CAPRICORN MUNICIPAL DEVELOPMENT GUIDELINES

MEETING MINUTES, POST AMALGAMATION MEETING 10

Venue: Gladstone Regional Council, Calliope Training Room, Don Cameron Dr, Calliope
 Date and Time: Wed 18th October 2017
 9:30am – 3:30pm

Figure 1: Example of Direct Line of Sight Assessment

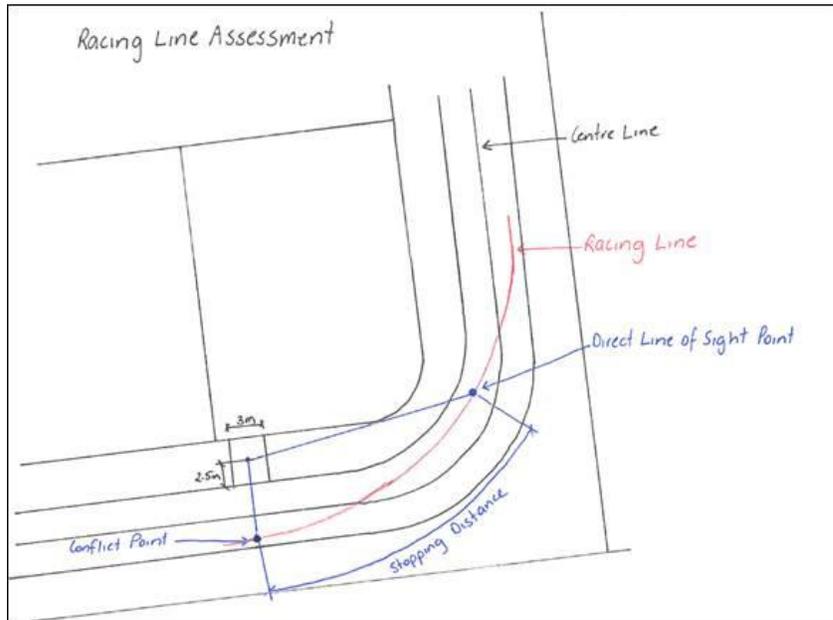
- 'Direct Line of Sight Point' on the racing line where the driver has direct line of sight to the middle of the driveway (2.5m from the curb at 1.15m height),
- 'Conflict Point' of vehicle exiting the driveway and the vehicle on the racing line, and,
- Distance along the racing line between the 'Direct Line of Sight Point' and the 'Conflict Point'

Driveway has adequate sight distance if the distance along the racing line between the 'Direct Line of Sight Point' and the 'Conflict Point' is less than the Stopping Sight Distance (SSD) required for the Design Speed of the Racing Line. See Figure 1 for an example of a Racing Line Assessment.
